Item Name: Crosstube Assembly, Mid Fwd

<b>DART AEROSPACE LTD</b> HAWKESBURY, ONTARIO, CANADA	
DRAWING NO. D206-667-147	REV. A SHEET 1 OF 4
TITLE CROSSTUBE ASSY (206L MID FWD)	SCALE NTS
COPYRIGHT © 2010 BY DART AEROSPACE LTD THIS DOCUMENT IS PRIVATE AND CONFIDENTIAL AND IS SUPPLIED ON THE EXPRESS CONDITION THAT IT IS NOT TO BE USED FOR ANY PURPOSES OR FOR COMMUNICATIONS TO ANY OTHER PERSON WITHOUT WRITTEN PERMISSION FROM DART AEROSPACE LTD.

DRAWING NO. D206-667-147	TITLE CROSSTUBE ASS'Y (206L MID FWD)	REV. A	<b>DART AEROSPACE LTD ENGINEERING ORDER</b>		D.E.O. NO. D206-667-147-A-1	SHEET NO. SHEET 1 OF 1	SCALE NTS
DRAWN 47	CHECKED AJS	MFG. APPR. [Signature]	APPROVED [Signature]		DE APPR. [Signature]		
DATE 11.07.15	DATE 11.07.20	DATE 11.07.21	DATE 11.07.21		DATE 11.07.21

**PURPOSE:**

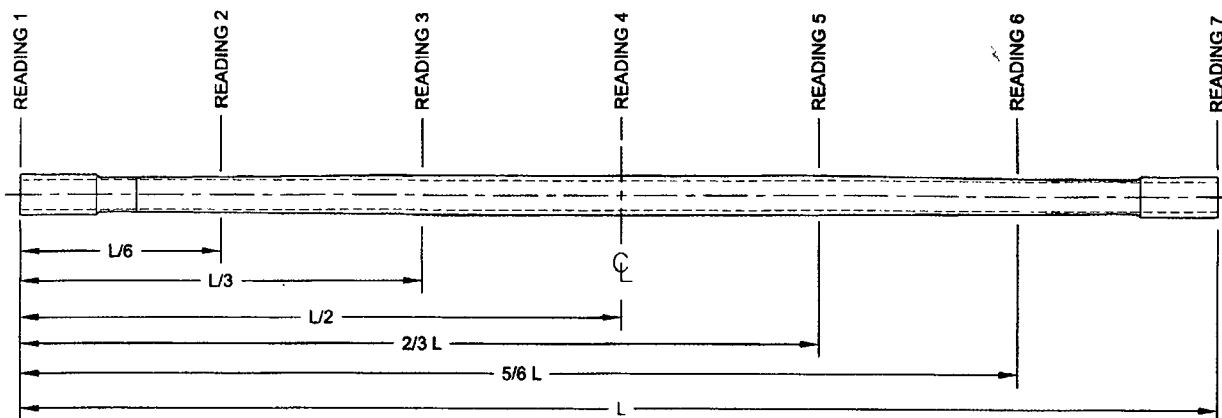
REPLACE MAGNOBOND WITH PROSEAL.

NOTE 12 & 15, SHEET 1 IS AMENDED AS FOLLOWS:

- 12) INSTALL D2891-1 SUPPORT USING 0.03" TO 0.06" THICK LAYER OF MAGNOBOND 6398 PER QSI 015. LET CURE FOR 12 HOURS AFTER INSTALLATION AND PRIOR TO PACKAGING.
- 15) TORQUE CLAMPS 80 TO 100 IN-LB. ENSURE AT LEAST 1.5 THREADS SHOWING IN SAFETY AND THAT NUT HAS NOT BOTTOMED-OUT AFTER TORQUING.

- 12) TO INSTALL D2891-1 SUPPORT: ABRASE MATING SURFACE OF SUPPORT AND CROSSTUBE WITH 180-GRIT SANDPAPER AND REMOVE RESIDUE WITH MEK (OR EQUIVALENT). APPLY A 0.04" TO 0.07" THICK LAYER OF PROSEAL 890 CLASS B-2 (OR AMS-S-8802 CLASS B-2) SEALANT TO MATING SURFACE OF SUPPORT.
- 15) TORQUE CLAMPS 80 TO 100 IN-LB. ENSURE AT LEAST 1.5 THREADS SHOWING IN SAFETY AND THAT NUT HAS NOT BOTTOMED-OUT AFTER TORQUING. **PRIOR TO PACKAGING, RE-CHECK TORQUE ON CLAMPS AFTER PROSEAL 890 SEALANT HAS CURED FOR 72 HOURS.**
